# 19-125FDP – THOMAS KOHLER PCD, SUBAREA E, MANGO'S PLACE DAYCARE

This is a request for review and approval of a Final Development Plan for a new 7,818-square-foot day care on a 2.17-acre lot.

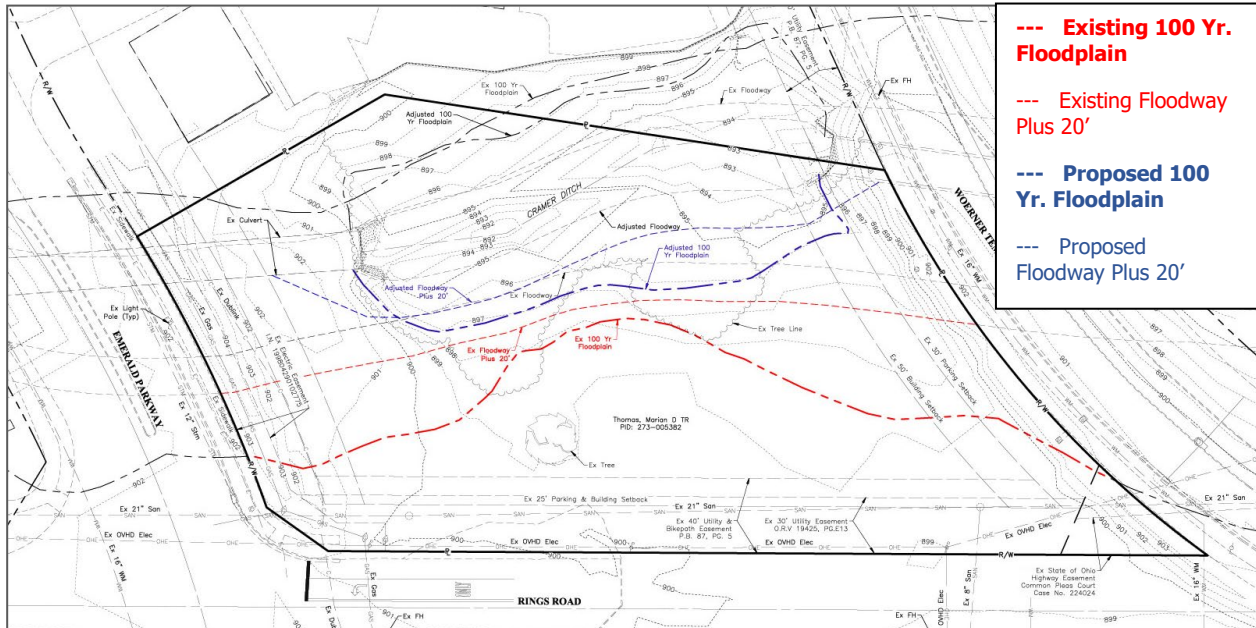
The Cramer Ditch runs through the northern portion of the property. This ditch creates a large 100-year floodplain that covers approximately half of the property. Trees are located in the northern and center portion of the site. The site slopes from the east to the west approximately six feet.

The applicant has submitted a detailed Letter of Map Revision (LOMR) study to the City of Dublin and FEMA to adjust the effective floodway and 100-year floodplain limits on the site. The relocation of both the effective floodway and 100-year floodplain is critical to the applicants' ability to develop due to the limited buildable space on the site. A Conditional Letter of Map Revision (CLOMR) had been previously approved by FEMA on September 30, 1999 to conditionally adjust the floodway and 100-year floodplain limits on the site. To complete this process, a Letter of Map Revision (LOMR) needs to be approved by FEMA to formally revise the effective floodway and 100-year floodplain limits on the site.

The applicant will be required to obtain an approved Letter of Map Revision (LOMR) from FEMA to formally revise the effective floodway and 100-year floodplain limits on the site prior to building occupancy to the satisfaction of the City Engineer. Additionally, the applicant will be

required to demonstrate compliance with Chapter 151 – Flood Control of the City of Dublin Code of Ordinances to the satisfaction of the City Engineer. The applicant is moving forward with this application with the intent of a Letter of Map Revision (LOMR) being approved by FEMA, which will create additional buildable area for the parcel, which is displayed in the following illustration.
